Item #	Document name, reference or page number	Clause or Section number	Clarification Comment, Content, or Question	Answer from Employer (Eskom & TPS)
1	SPECIFICATION FOR THE 400 KV, 500 MVAR, DYNAMIC REACTIVE POWER COMPENSATOR FOR ARIES SUBSTATION	-	Please, confirm that the warranty period for Dynamic Reactive Power Compensation for Aries Substation is limited to two years and equals to RAM period	The Defect Liability Period (DLP) is 156 weeks and the RAM is for two year period, but as noted in the respective clauses.
2	Commercial Queries	Approved suppliers	Do you have an approved supplier list? Kindly asking to share it if yes	Bidders can propose preferred suppliers, Eskom reserves the right to review and approve if all requirements are met including but not limited to commercial, technical and other specifications.
3	TECHNICAL EVALUATION OF PROPOSALS FOR THE 400KV, 500MVAR, DYNAMIC REACTIVE POWER COMPENSATOR FOR ARIES SUBSTATION	4.2.1. (1) and Annex A	Please, confirm that System Designer experience requirement is related to the bidding stage of the tender or to the main project stage.	System Designer experience requirement is related to both bidding stage and main project stage

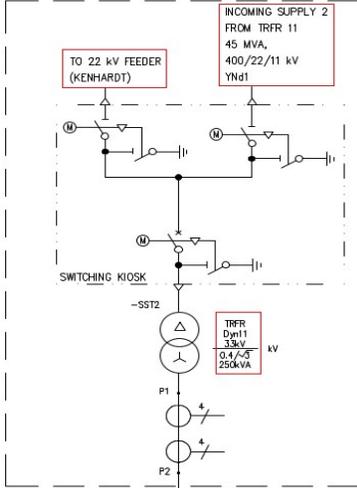
44	STATCOM Specification ST_240-103797616 Rev 3	6.17.10 9) Page 136	<p>Leak detectors shall be provided.</p> <p>A sensor for leak detection within the cooling system replaces this. Please confirm.</p>	<p>Not accepted. To be reviewed at design stage, at discretion of Eskom (Employer) and if needed, both leak detectors within the cooling system be provided plus compliant detectors.</p>
